Belmac Community Members and Neighbours

Community Engagement

Area Redevelopment Plan

Figure 9: Street Network

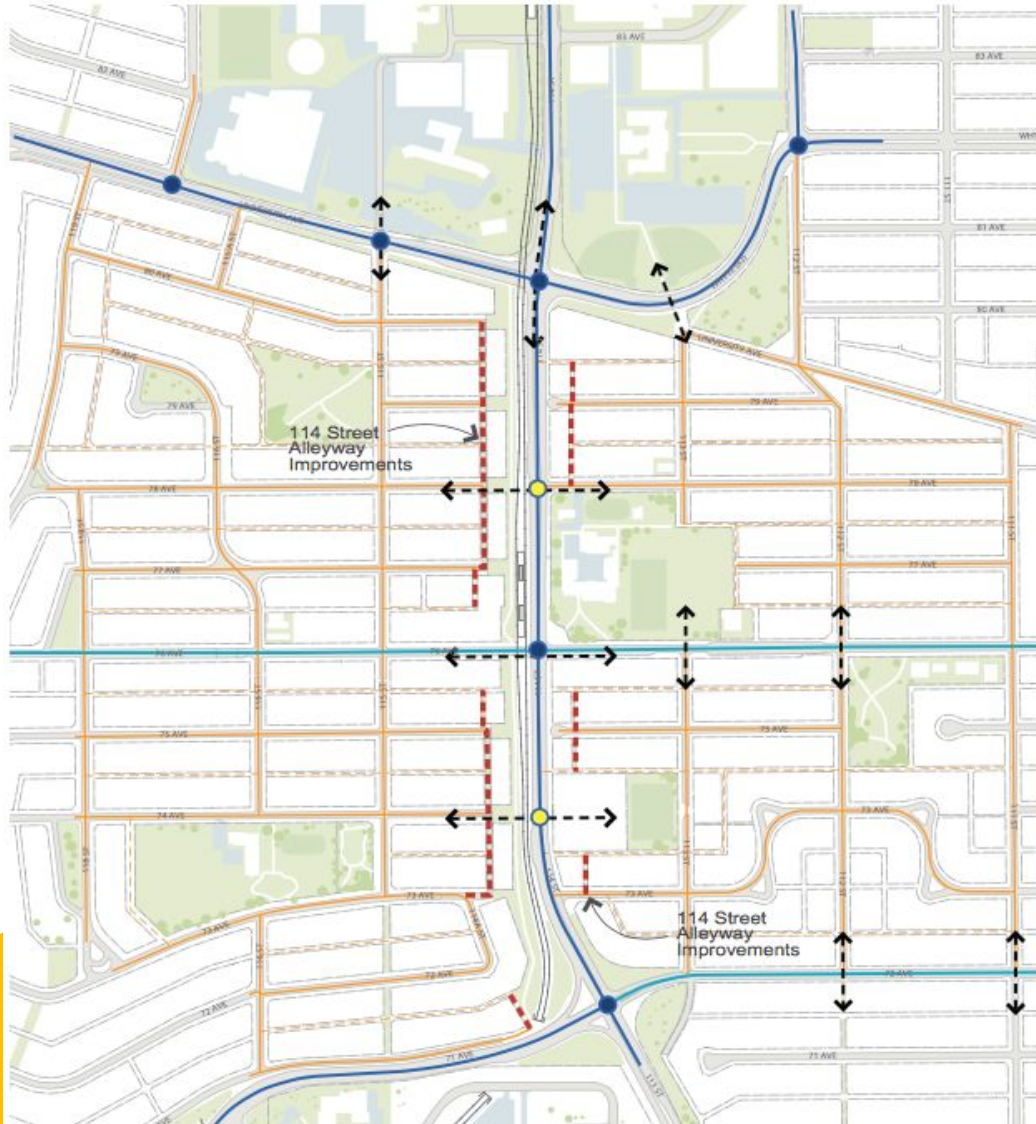
- Developer contends that they have identified an error – a missed “gateway”
- “Pedestrian Gateway”
 - Crosswalk, North edge of LRT, no dedicated east-west bike lanes
- *At the South End (2 blocks away) – there is an underground pathway, east-west bike lanes ☐ More appropriate pedestrian entrance to the area*
- This location has not changed since 2013

- There is no gateway
- This site identified as **intersection** in original documents
- ***Why are they calling it a Gateway?***
- “Gateway” = 6-Storey development
 - associated with major intersections, design that supports multi-use traffic including vehicles, and few impediments to passage
